Hip Bone Creek Baseline Monitoring Report

Hip Bone Creek Restoration Site
Cape Fear River Basin - 03030003
Monitoring Year 00
DMS Contract 7528
DMS Project Number 100059

MEMORANDUM

Subject: Hip Bone Creek Mitigation Site
MY-00 Baseline Monitoring Report Comments
Cape Fear River Basin CU 03030003
NCDMS Project # 100059
Contract # 7528

SITE PLAN

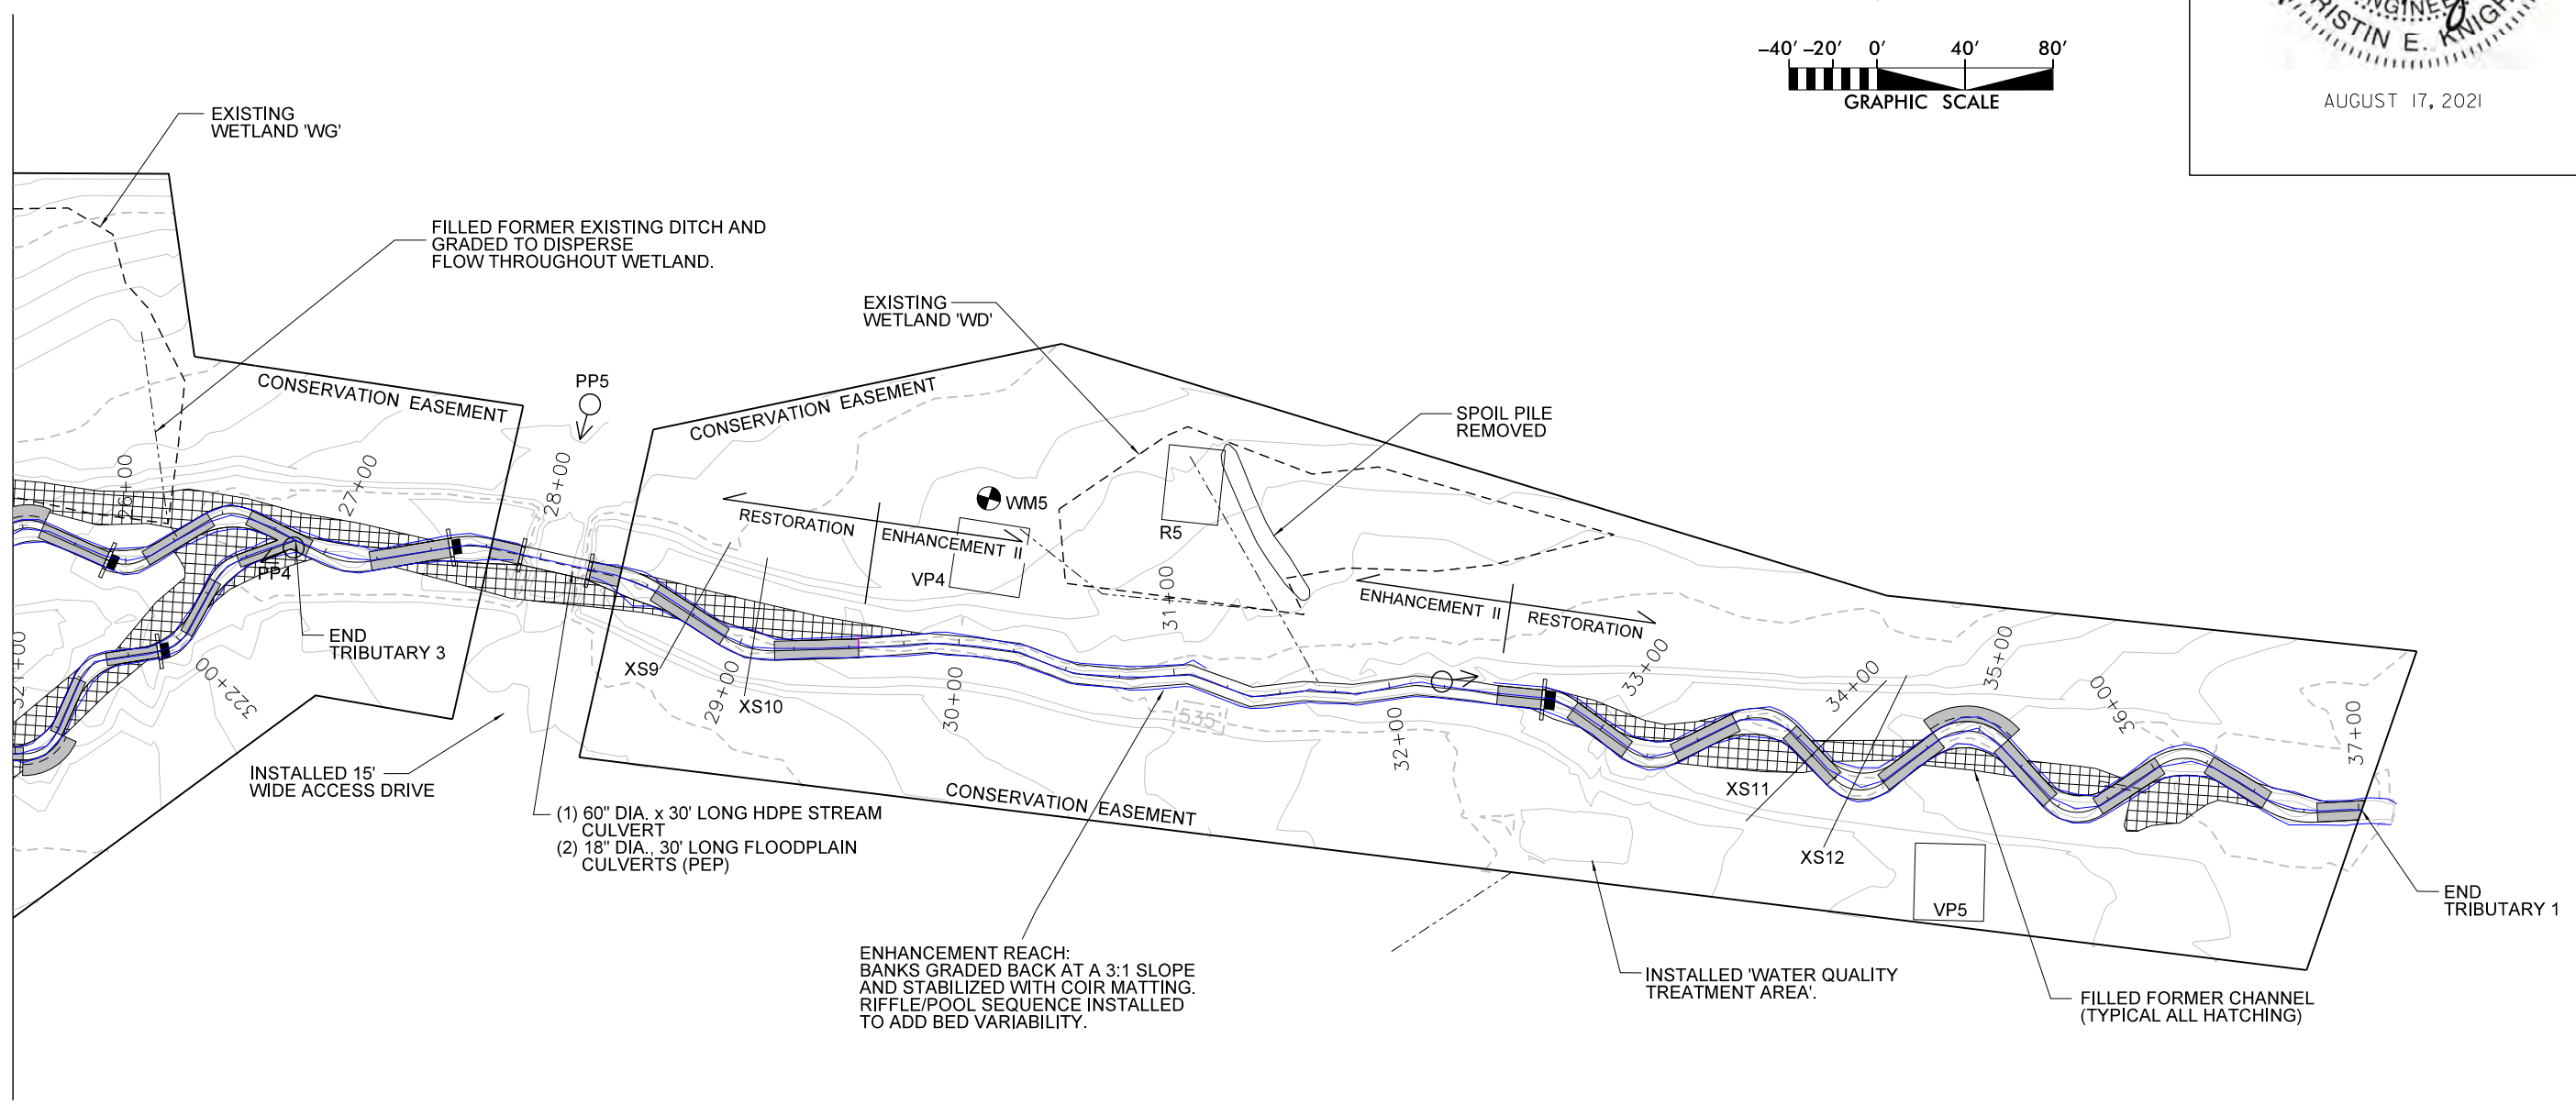
- Recommend removing callouts for in-channel structures that are not a deviation from design. For example, on Sheet 3 the “Installed ‘Step Pool’ (TYP.)” can be removed along with the other stream structure callouts.
KCI Response: This change has been made.

DATE	AUGUST 2021
SCALE	GRAPHIC
PLANTING PLAN	
SHEET 8 OF 11

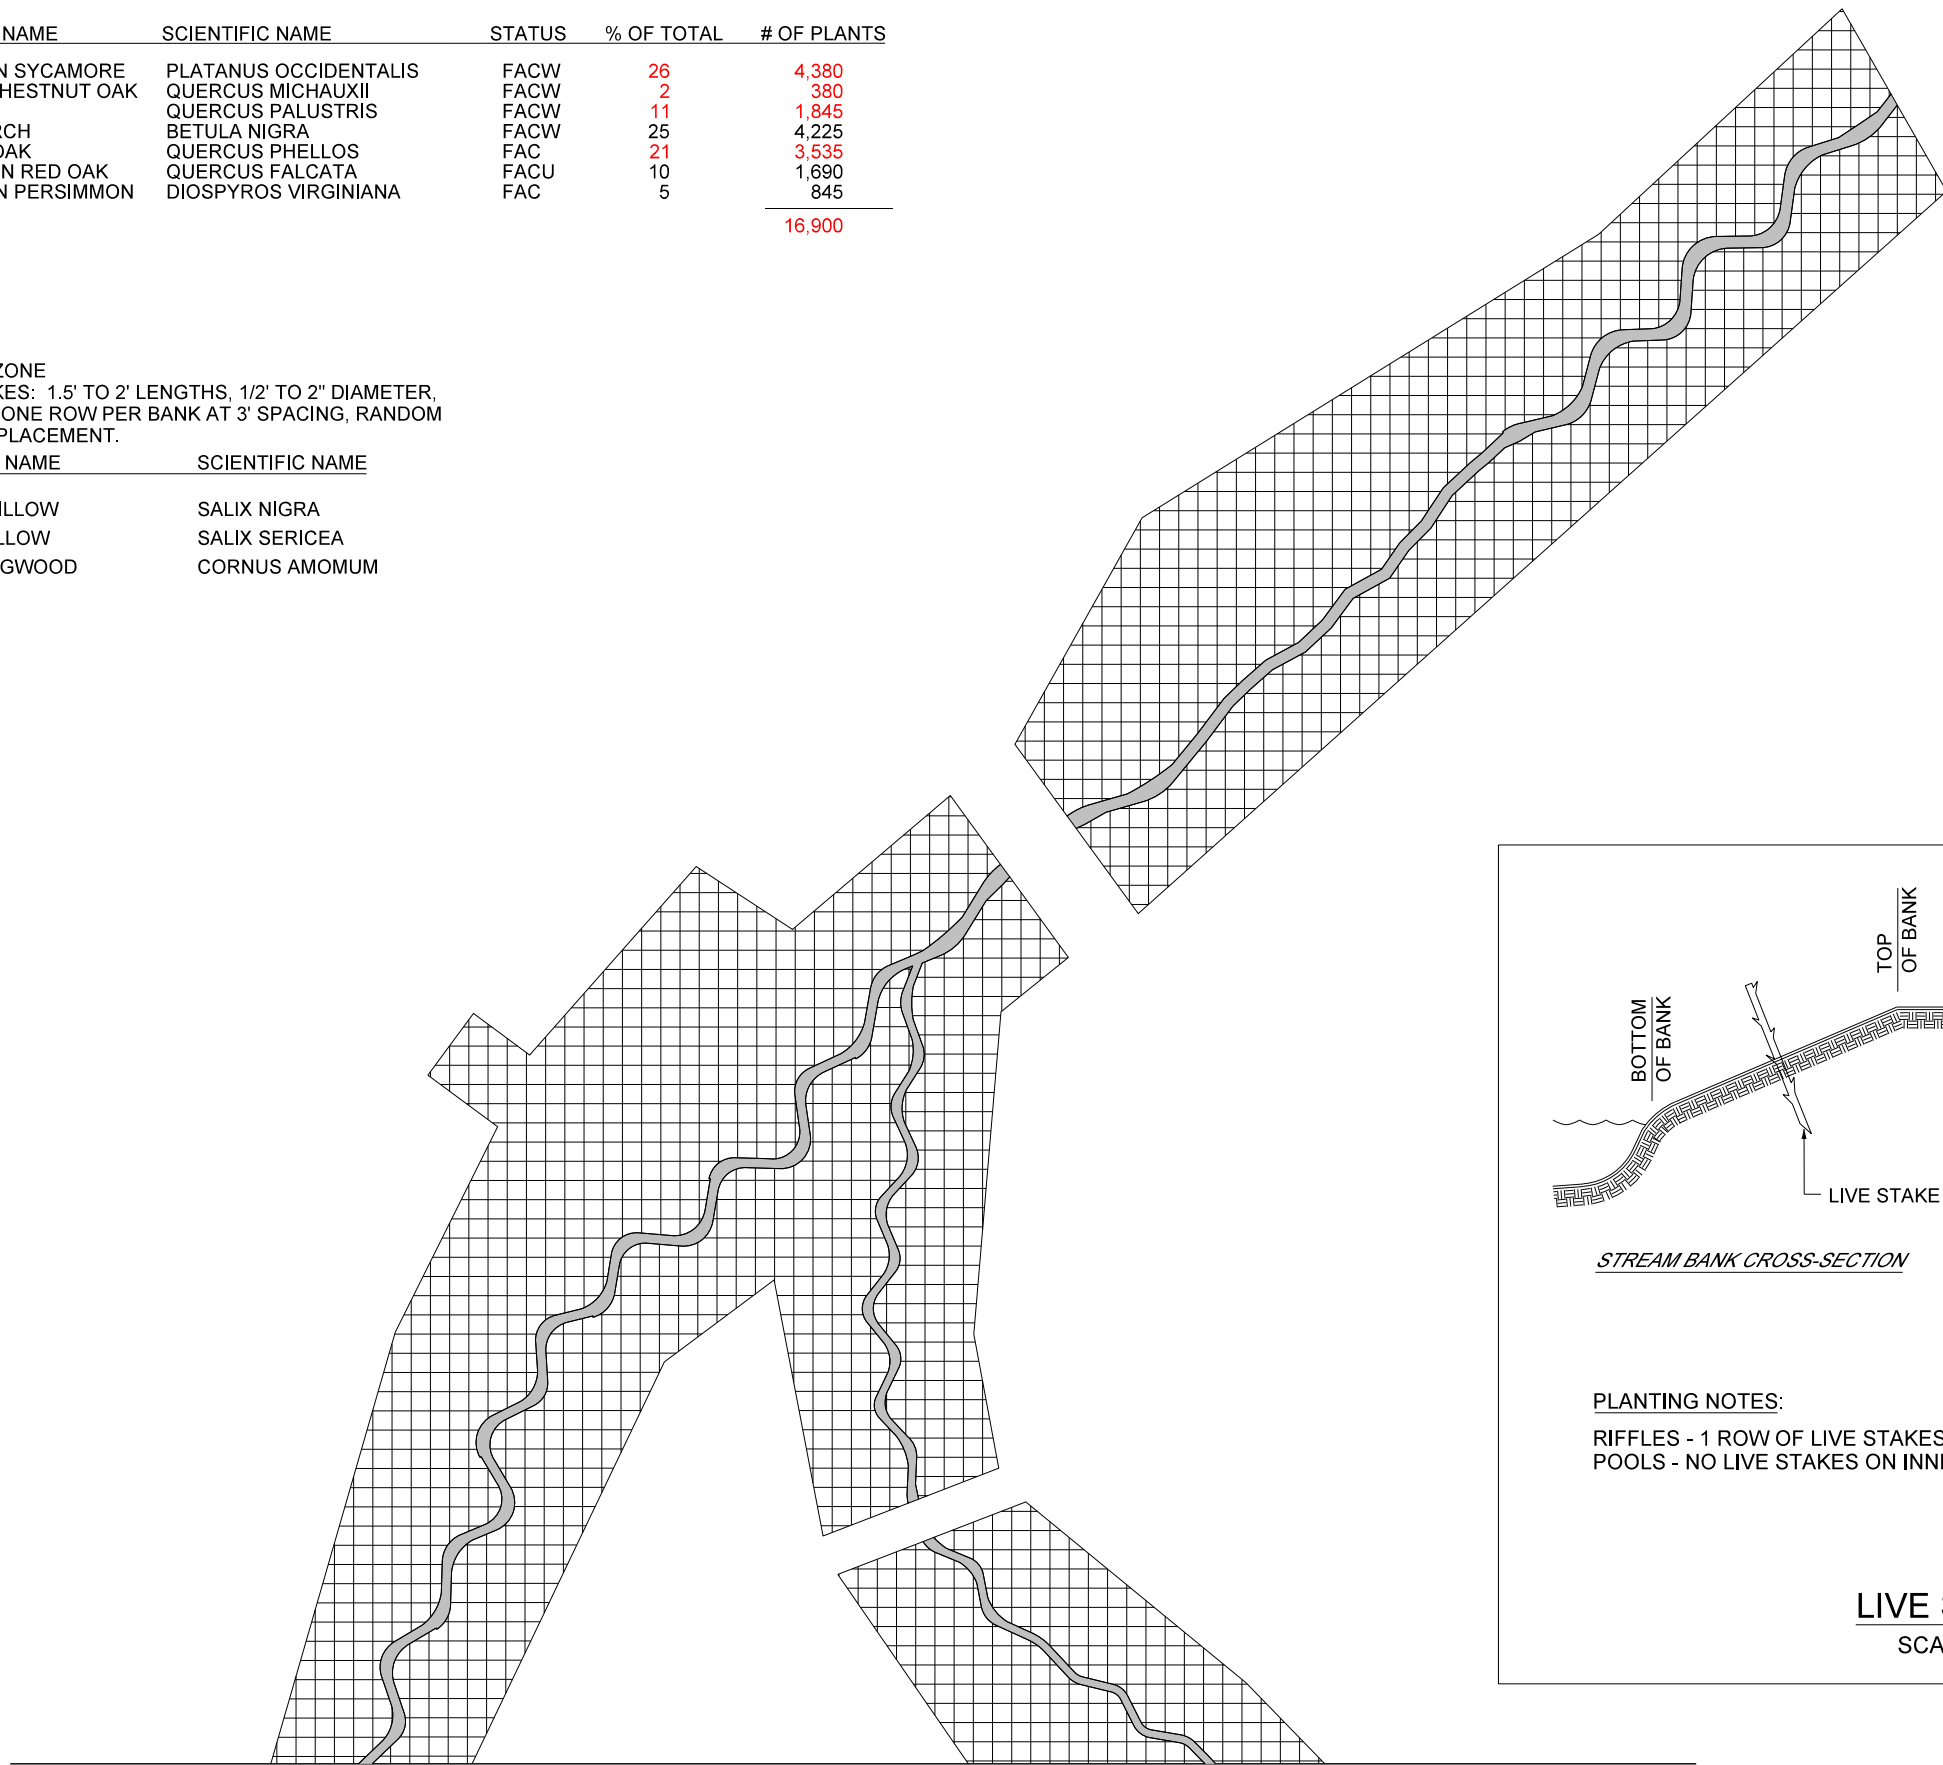
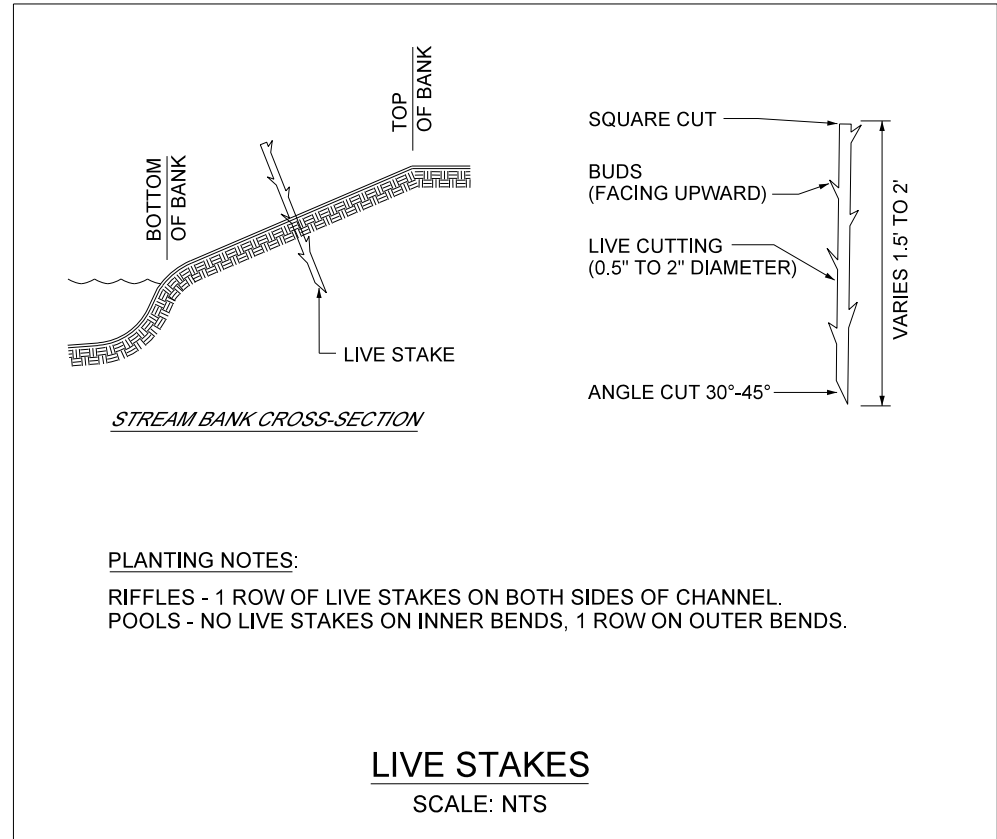
- Sheet 8 – River Birch, Southern Red Oak, and Persimmon species did not change from the amount proposed in the mitigation plan and should be colored black.
KCI Response: This change has been made.
